REPUBLIC OF KOREA
Ministry of Land, Infrastructure and Transport
Office of Civil Aviation
11, Doum 6-ro, Sejong-si, 30103, Republic of Korea

AIRAC
AIP
Supplement 74/25
21 AUG 2025

A D : MUAN/Muan INTL(RKJB)

CHANGE OF RWY 01/19 DECLARED DISTANCE

4. DIAGRAM

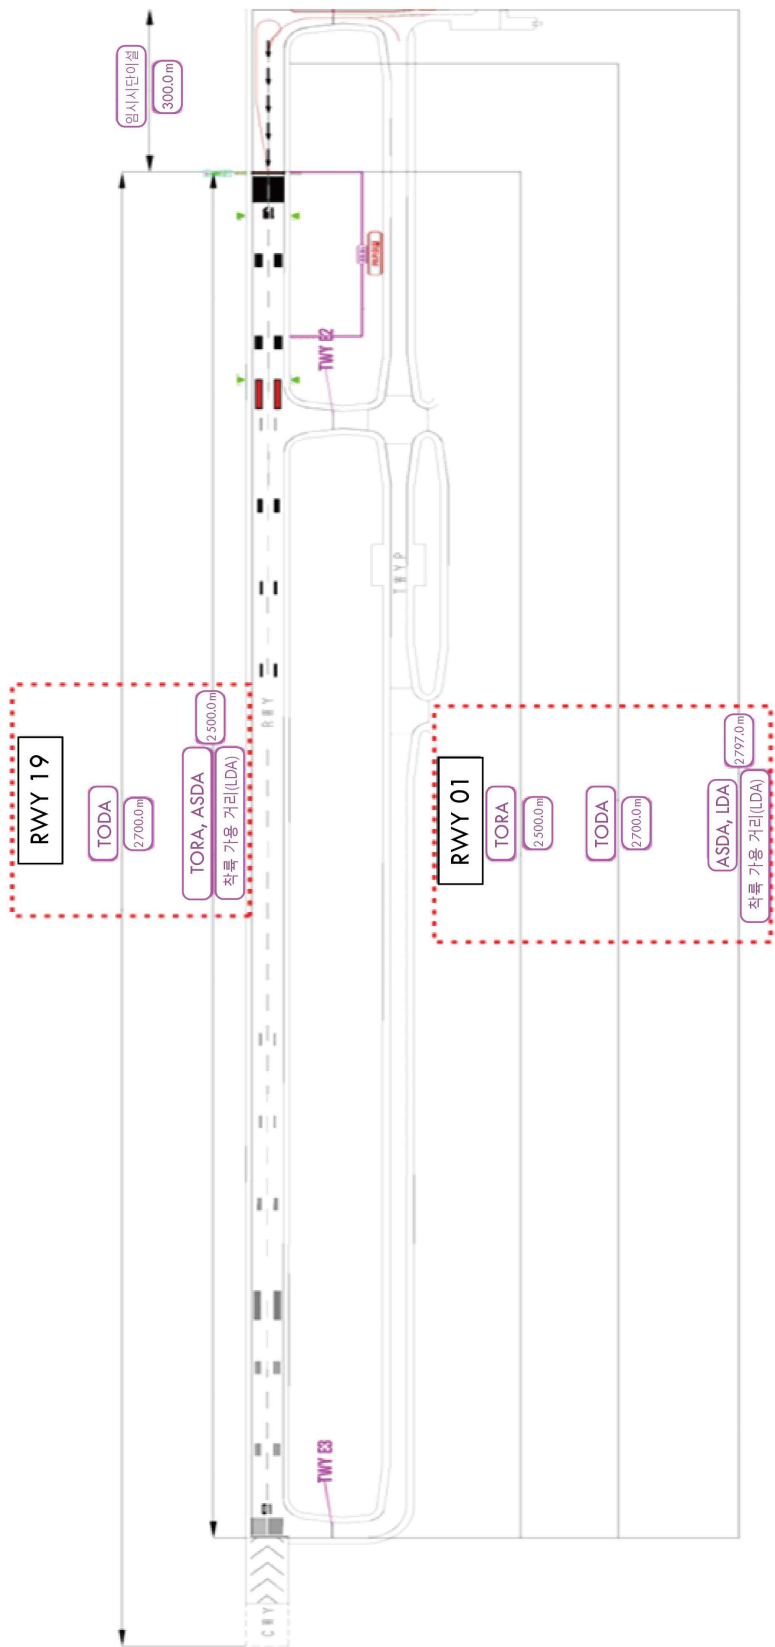
RWY 01/19 declared distance will be changed below.

TORA(m)	TODA(m)	ASDA(m)	LDA(m)	Remarks
RWY 01	2 500	2 700	2 797	2 797	NIL
RWY 19	2 500	2 700	2 500	2 500	NIL
RWY 19	2 057	2 257	2 057	2 057	Take-off from intersection with TWY E2

- (1) The ASDA and LDA for RWY 01 are not affected by displacement of RWY 19 THR.
(AIRAC AIP SUP 75/25(RWY 19 threshold displaced by 300 m))
- (2) Any change to the contents of these pages will be notified by NOTAM.
- (3) See the diagram below.
